Technical Memorandum

To: Ann Foss, Minnesota Pollution Control Agency; Jess Richards, Minnesota Department of Natural Resources; Kenton Spading, U.S. Army Corps of Engineers
Prepared for: Poly Met Mining, Inc.
From: Don E. Richard, PhD, P.E.
Subject: Proposed Waste Water Treatment System (WWTS) Relocations (Version 3)
Date: April 11, 2017
c: Jennifer Saran, Christie Kearney, PolyMet

Subject: Proposed Waste Water Treatment System (WWTS) Relocations (Version 3)

Large Figure 7
Operations Mine Years 1 to 11: Comparison of FEIS Flows and Proposed Flows with WWTS Relocations

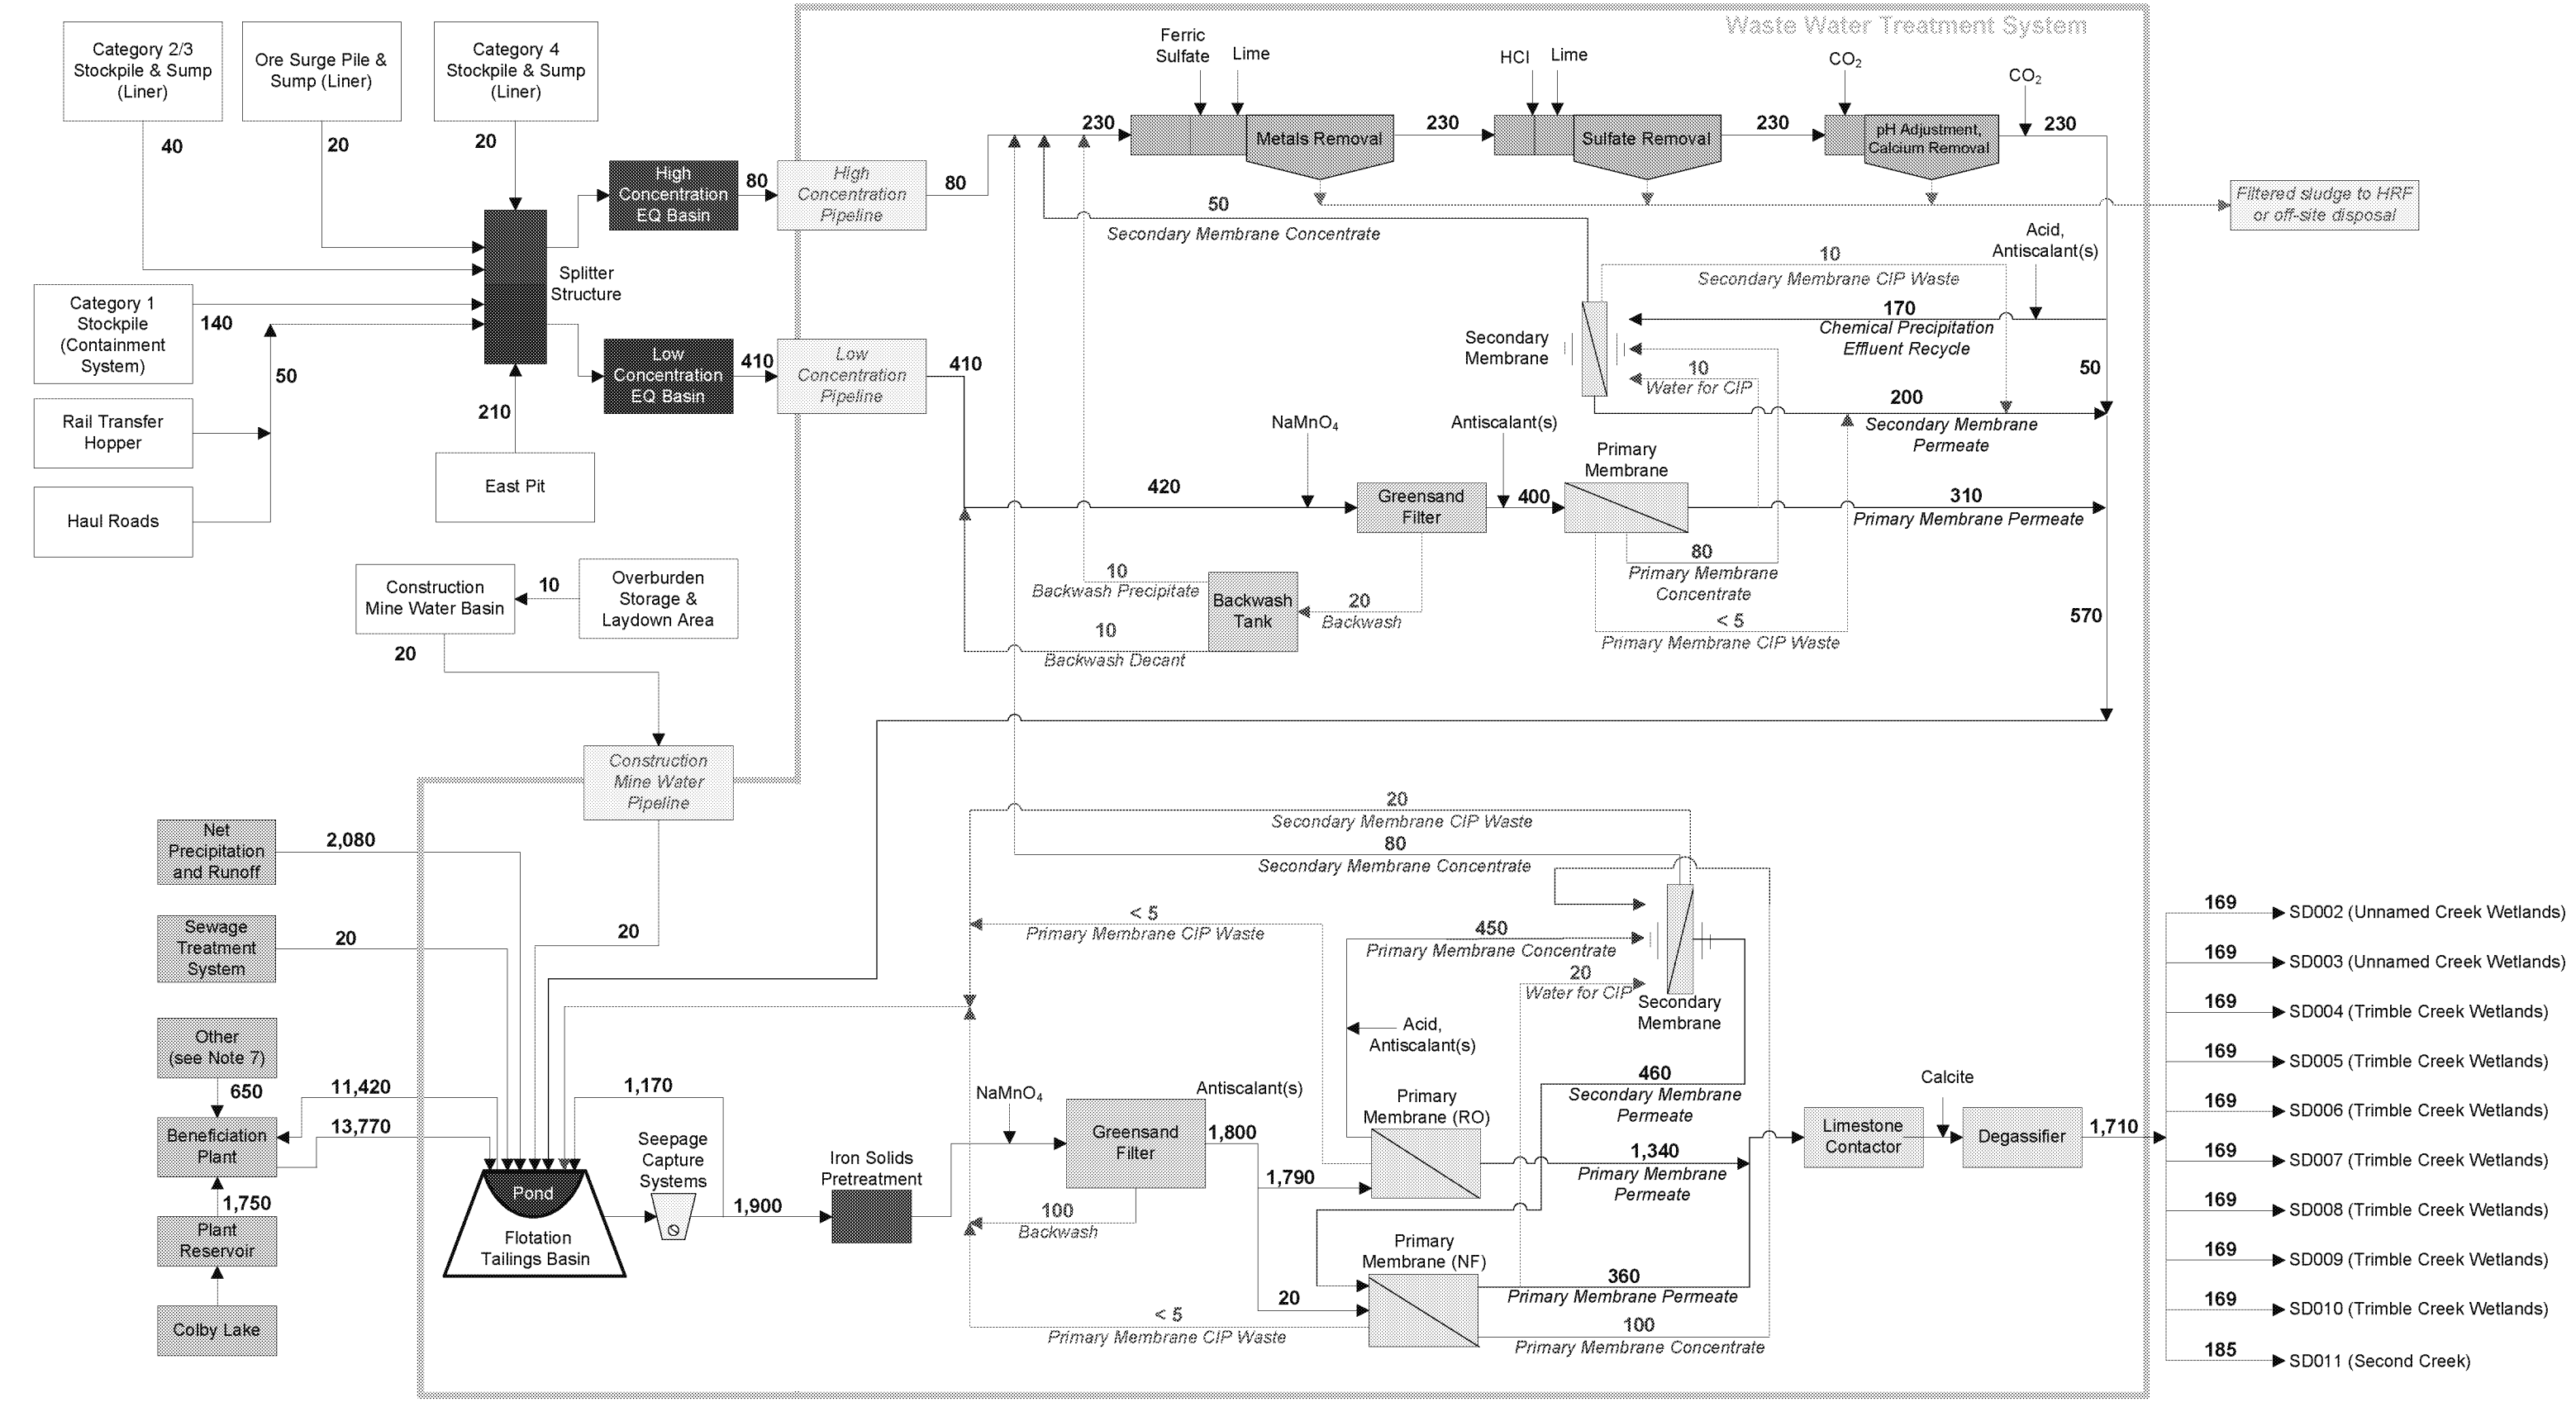
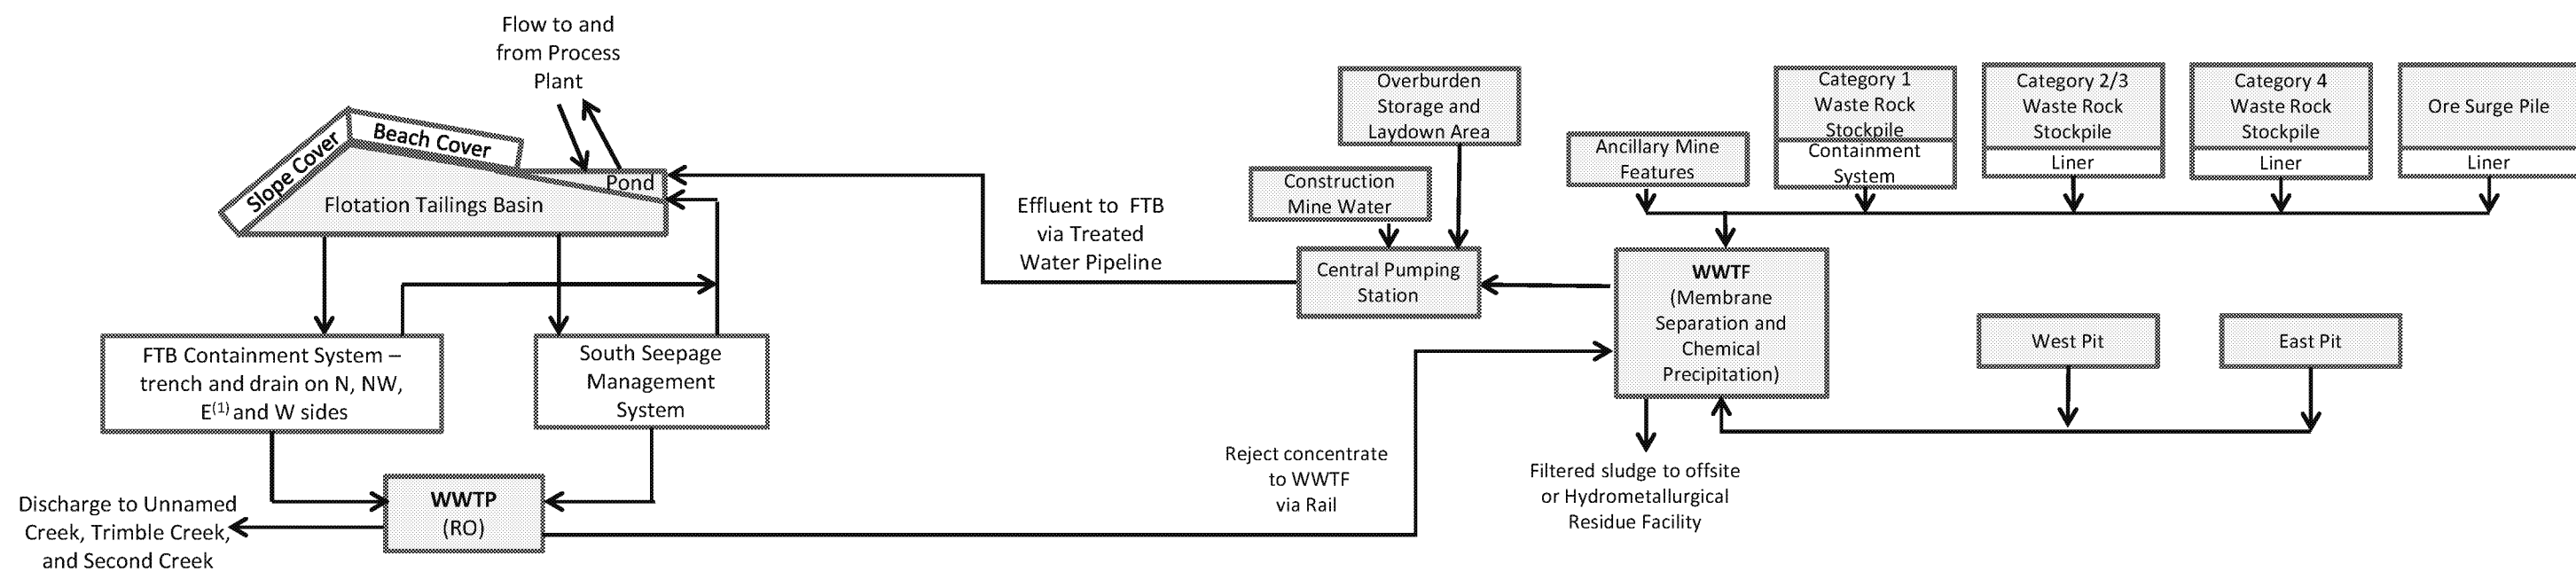
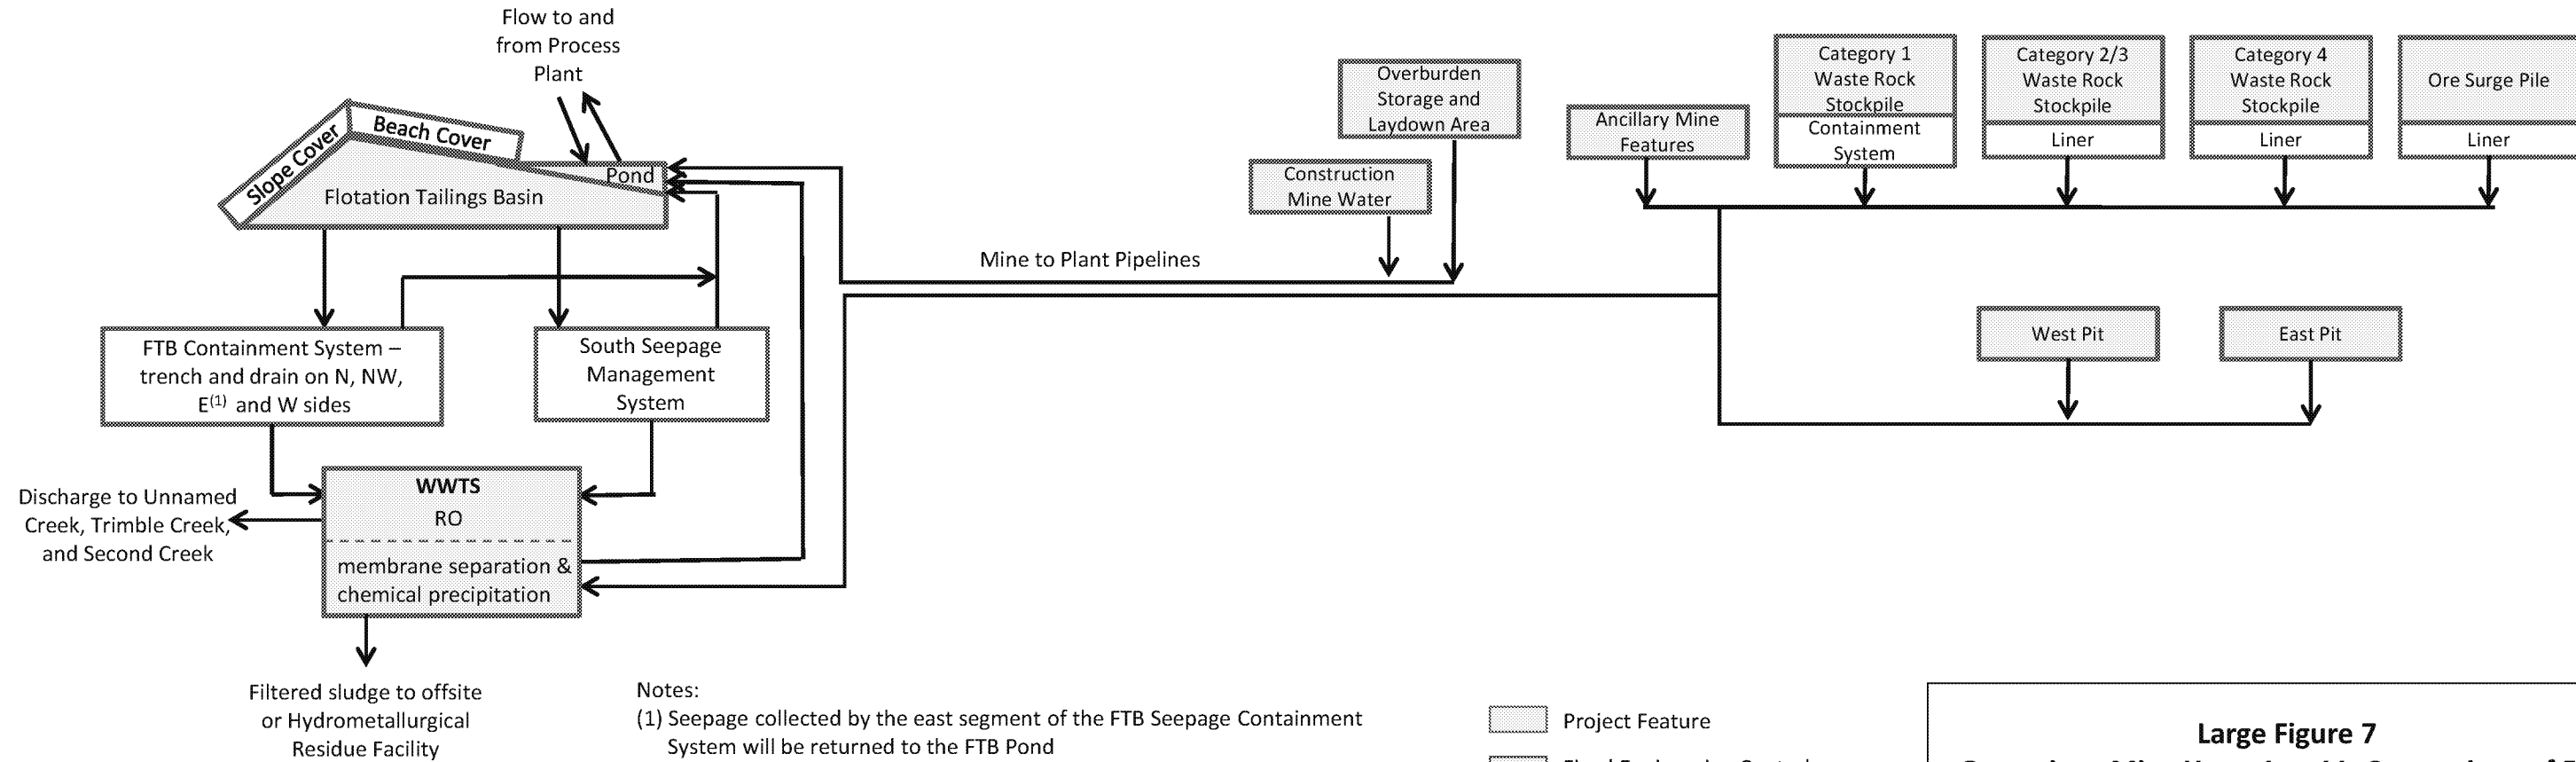
During operations (Large Figure 7 and Large Figure 8), mine water would be sent to the Plant Site via the Mine to Plant Pipelines located within the Transportation and Utility Corridor, along the alignment planned for the Treated Water Pipeline. The construction mine water would go to the FTB Pond, as it previously had in the FEIS (i.e., previously combined with the treated mine water at the CPS Pond, which was then routed through the Treated Water Pipeline to the FTB Pond). The high concentration mine water would report to chemical precipitation treatment units at the WWTS, and the low concentration mine water would report to membrane filtration treatment units at the WWTS, as was the case in the FEIS configuration of the WWTF. Treated mine water from the membrane separation and chemical precipitation treatment units at the WWTS would be routed to the FTB Pond. When East Pit backfilling begins in approximately Mine Year 11, treated mine water would be routed back to the Mine Site through the Construction Mine Water Pipeline. Treated mine water and OSLA runoff would both be used in water level management during East Pit backfill, with that operation proceeding at the same rate of backfill and water level management as evaluated for the FEIS and with the same type of water as was evaluated for the FEIS. Accordingly, the WWTS relocations would result in no change in management of water from the FTB seepage capture systems as compared to the prior configuration: some water would be returned to the FTB Pond, and some water would be sent to the WWTS for treatment and then discharged under the terms of an NPDES/SDS Permit and the Water Appropriation permits. The quantity, quality, and location

Large Figure 10
Postclosure Maintenance: Comparison of FEIS Flows and Proposed Flows with WWTS Relocations

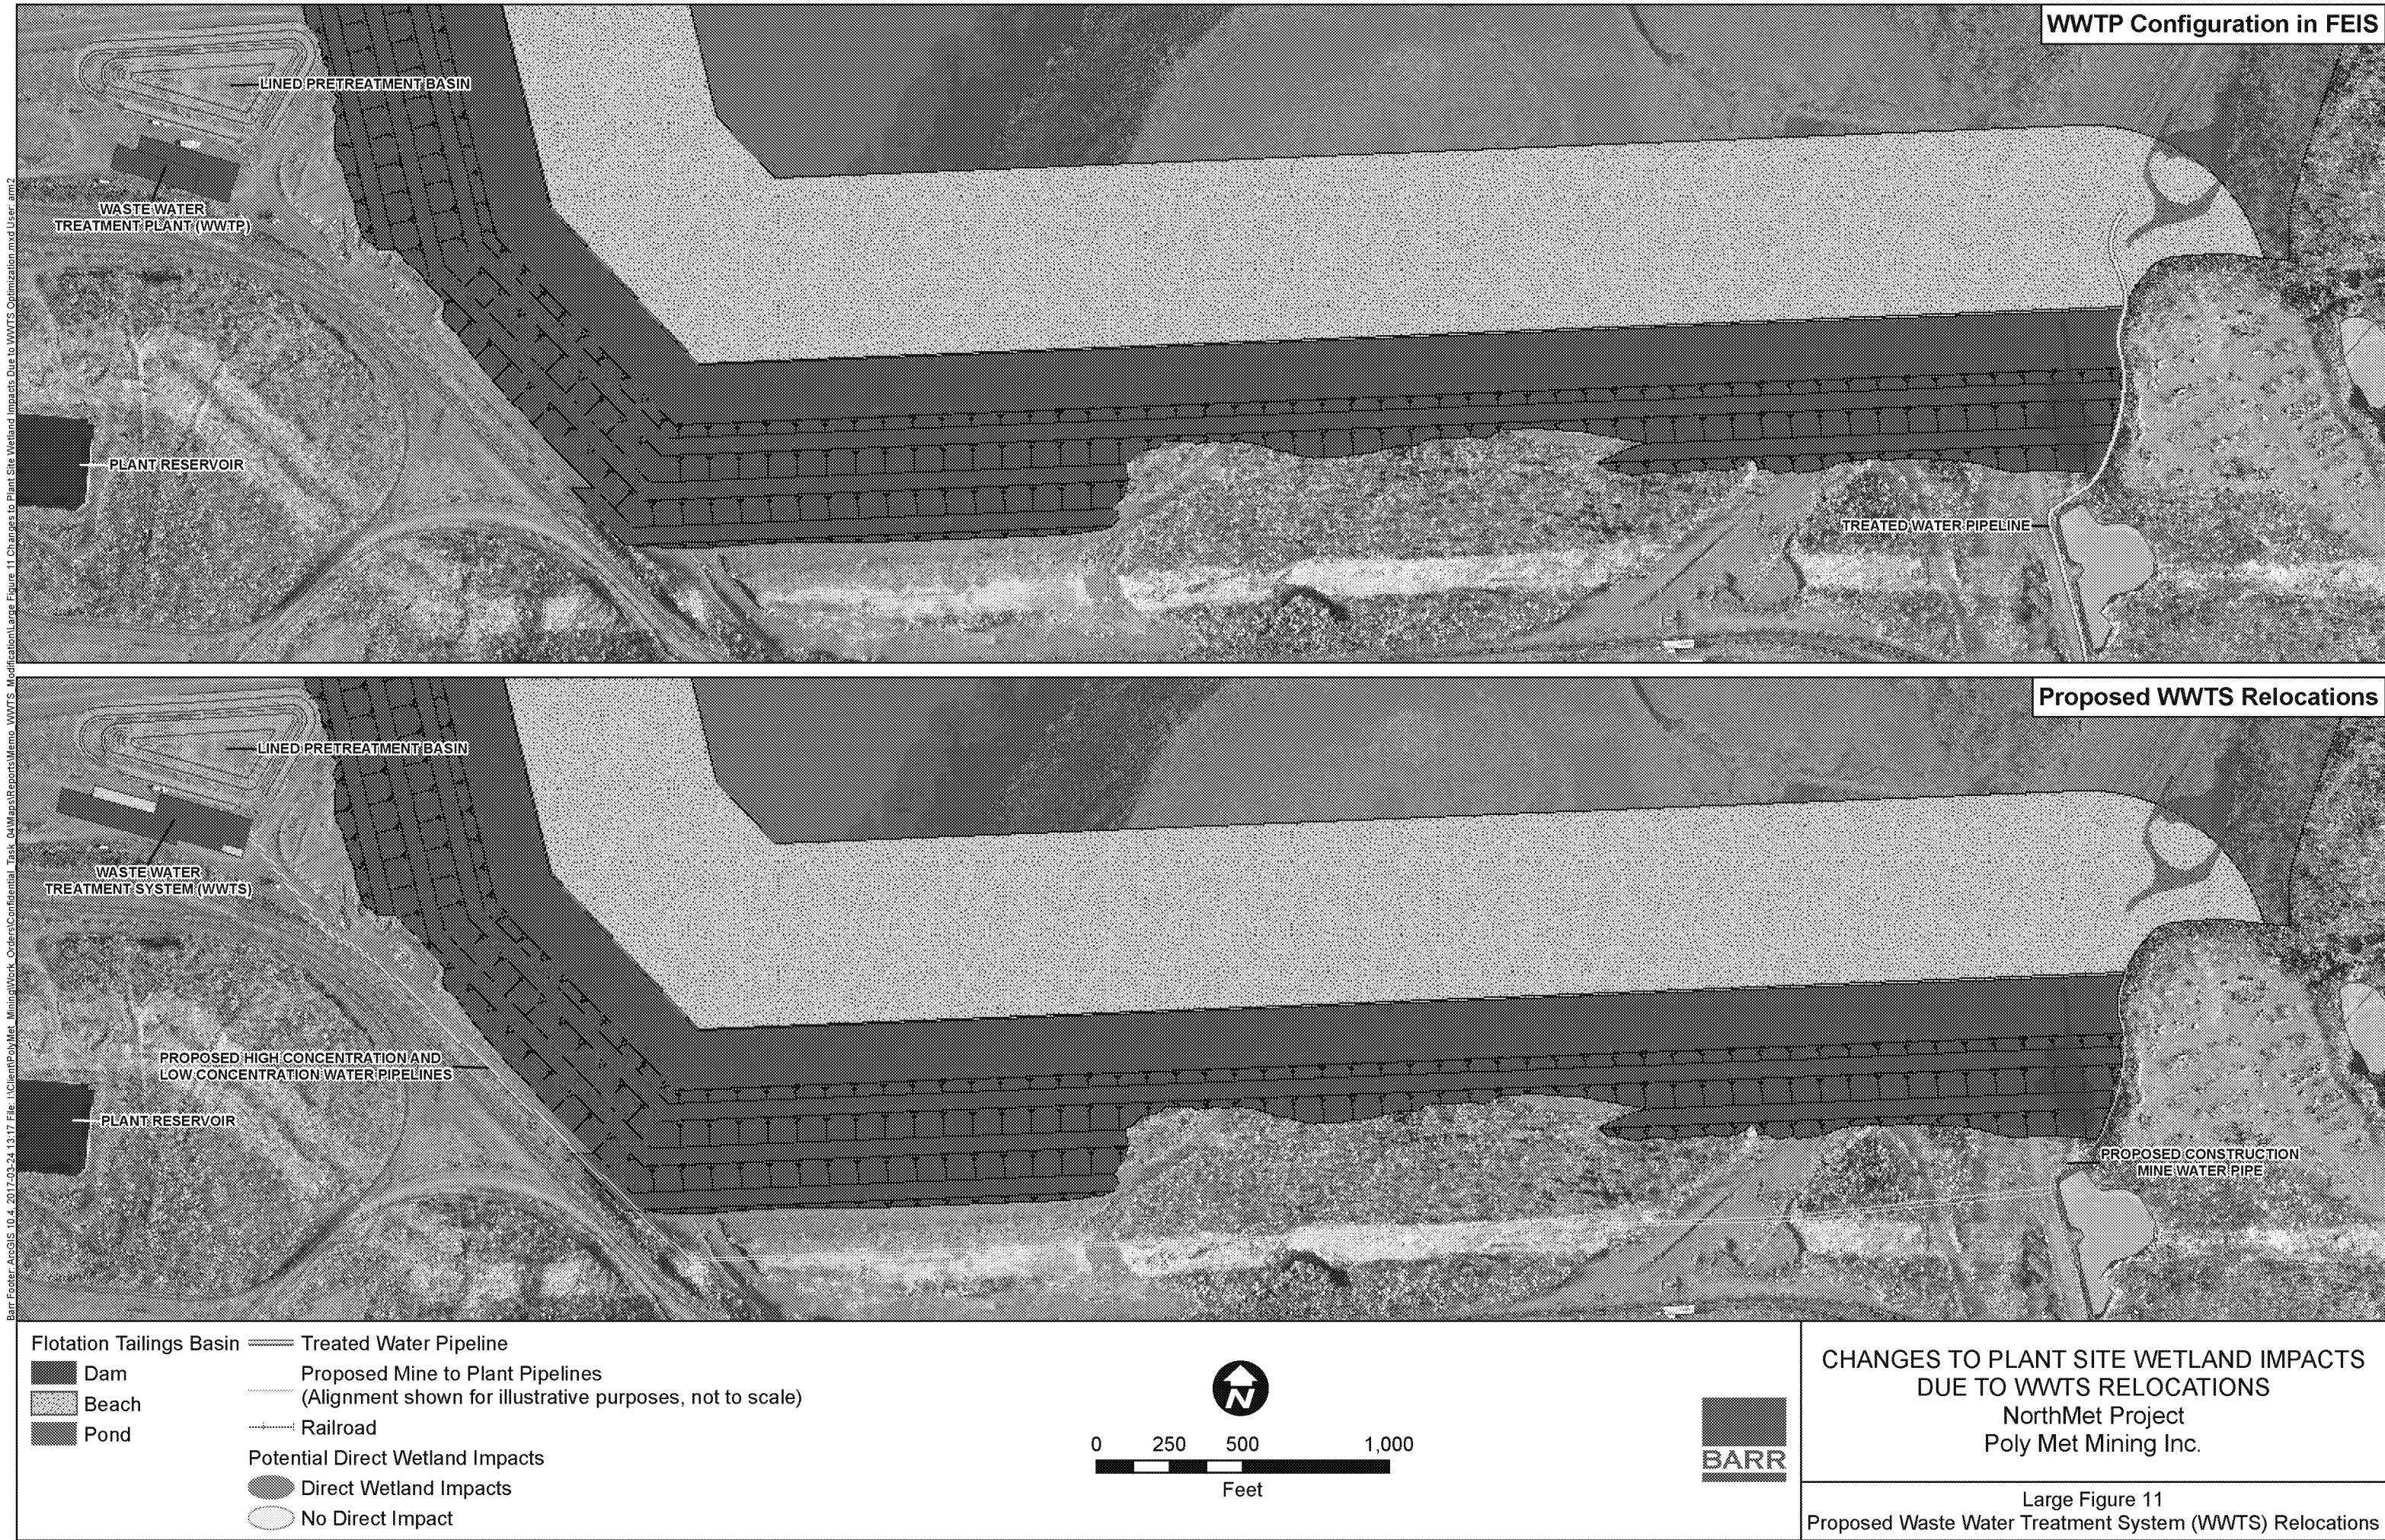
During postclosure maintenance (Large Figure 10), while mechanical water treatment continues, mine water would be sent to the WWTS for treatment and returned to the Mine Site for discharge to the environment at the same rates and quantities as evaluated for the FEIS. One EQ basin and two Mine to Plant pipelines would remain in use during this phase. The basin and one pipeline would be used to send mine water from the West Pit and the Category 1 Waste Rock Stockpile to the WWTS. The second pipeline would be used to send treated water back to the Mine Site for discharge. As with previous phases, the WWTS relocations would result in no change in management of water from the FTB seepage capture systems and the quantity, quality, and location of discharge to the environment would be unchanged from what was evaluated in the FEIS and Permit to Mine application.
